City of Santa Fe
Historic Districts Review Board
Findings of Fact and Conclusions of Law

Case #H-13-068

Address – 435 Arroyo Tenorio

435 ARROYO TENORIO - STREET ELEVATION

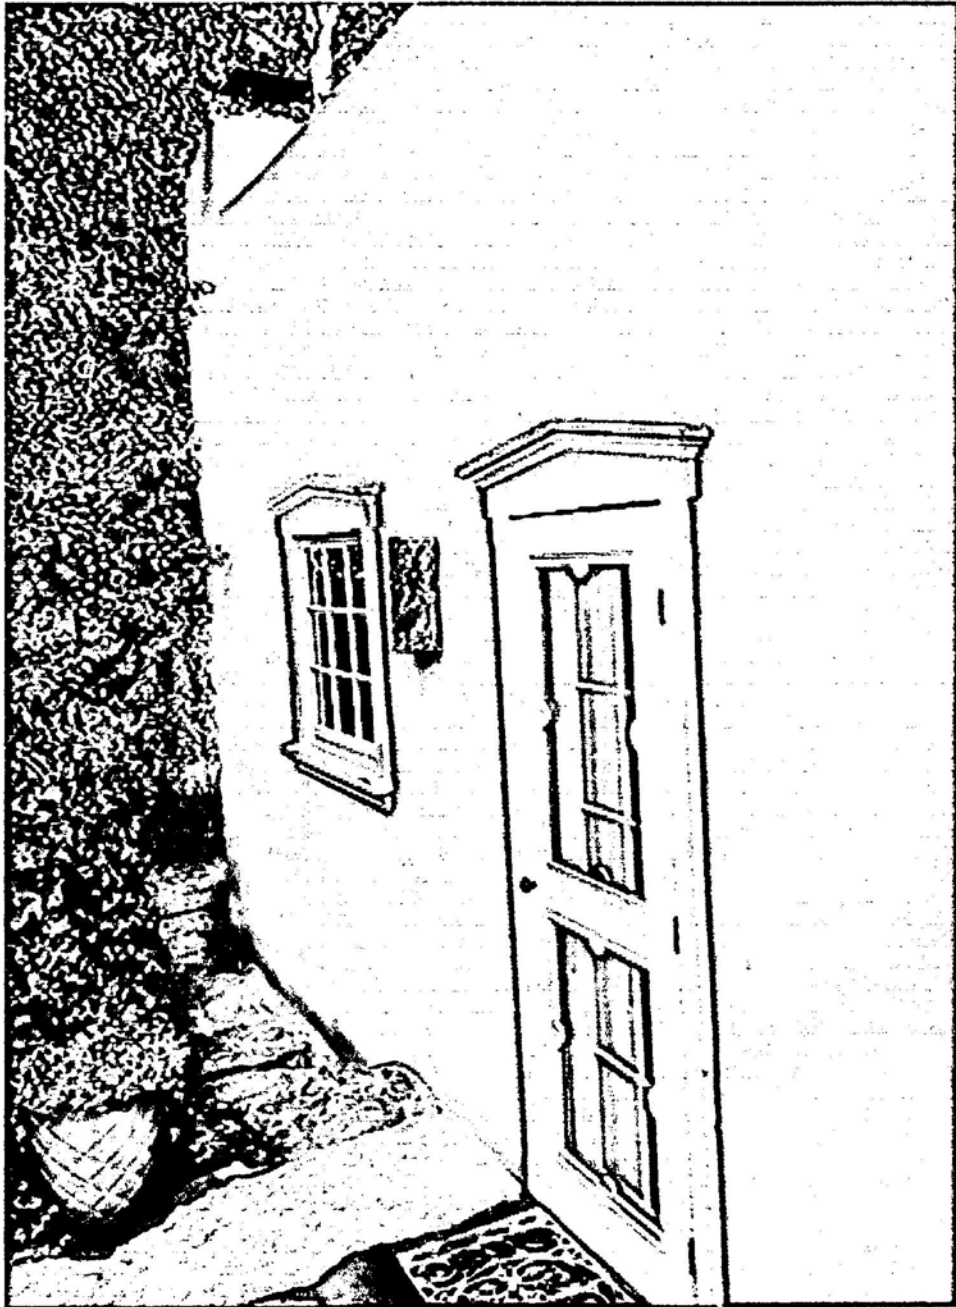
Ms. Walker said on the field trip she asked if the gate was fenestrated.

Mr. Rasch said it appeared to not be fenestrated.

Ms. Walker asked if he was enlarging the vehicular gate.

Ms. Walker asked if he could fenestrate the gate.

Ms. Ritter agreed to redesign it and explained that he was just trying to replicate the existing gate.

Ms. Rios asked if the gate was getting taller and wider.

Mr. Ritter said it would have the same height but he was expanding the width.

Mr. Katz moved to approve Case #H-13-068 approved with condition that the gate be fenestrated. Ms. Rios seconded the motion.

Chair Woods proposed an amendment that the new drawing for the gate be brought back to staff. Mr. Katz accepted the amendment as friendly and the motion passed by unanimous voice vote.

This is to certify that the Historic Districts Review Board (HDRB) at their hearing on August 13, 2013, the decision of the Board was to approve your request with the condition that the vehicle gate shall be fenestrated and that the design shall be approved by staff before a construction permit application is submitted. For further information please call 955-6605.
